Access Compliance Report

Public Rights-of-Way

Intersection ID: 26793	Main Street: JAMES_VALLEY_CT	Cross Street: MANOR_HOUSE_DR	Location: W
ADA ID: 6FEF25EA4B3E	Ramp Type: Perp	Initial Pass/Fail: Fail	Overall Compliance: No
		Severity Score: 1.25

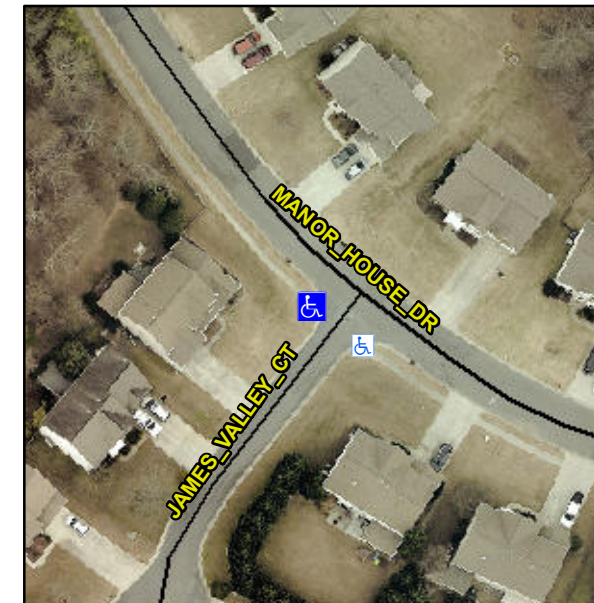
Not Found, R304.5.3

Compliance	Description	Data	Compliance	Description	Data
N/A	Ramp Length (in)	44.5	Yes	Ramp Slope (%)	5.0
Yes	Ramp Width (in)	48.0	No	Ramp XSlope (%)	2.9
N/A	Flare Type LT	N/A	N/A	Flare Type RT	N/A
N/A	Flare Slope LT (%)	N/A	N/A	Flare Slope RT (%)	N/A
N/A	Flare Traversable LT?	N/A	N/A	Flare Traversable RT?	N/A
N/A	Landing Length (in)	N/A	N/A	DWS Provided?	N/A
N/A	Landing Width (in)	N/A	N/A	DWS Contrast?	N/A
N/A	Landing Slope (%)	N/A	N/A	DWS Length (in)	N/A
N/A	Landing X Slope (%)	N/A	N/A	DWS Full Width?	N/A
N/A	Landing Curb? (Y/N)	N/A	N/A	DWS Offset (in)	N/A
N/A	Shared Landing?	N/A			
N/A	Gutter Ponding?	N/A	N/A	Gutter Slope (%)	N/A
N/A	Gutter Lip Ht (in)	N/A	N/A	Gutter X Slope (%)	N/A
N/A	Painted X Walk1?	No	N/A	Painted X Walk2?	N/A
	X Walk 1 Direction	To SE		X Walk 2 Direction	N/A
N/A	X Walk 1 Width (in)	N/A	N/A	X Walk 2 Width (in)	N/A
	X Walk 1 Slope (%)	0.6		X Walk 2 Slope (%)	N/A
	X Walk 1 X Slope (%)	1.9		X Walk 2 X Slope (%)	N/A

Remove & Replace Entire Ramp.
